# Comment-Response Document (CRD) 2018-06(B)

RELATED NPA: 2018-06(B) — RELATED ED DECISION: 2022/007/R — RMT.0379 31.1.2022

## CS AWO.A.ALS.115 Approach and automatic landing with an inoperative engine

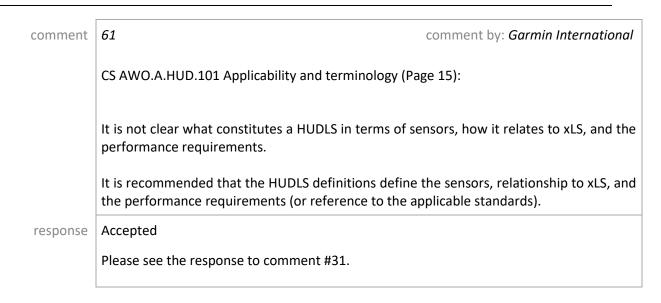
comment	86 comment by: AIRBUS
	An AMC CSAWO.A.ALS.115 should be added to this requirement as no limit is established on acceptable number of flights test and/or simulation is required to demonstrate acceptable performance of the system one engine inoperative.
	Please add an AMC.
response	Not accepted
	AMC AWO.A.ALS.108 already addresses the number of landings performed and the statistical analysis. Therefore, there is no need to repeat this information in the AFM.
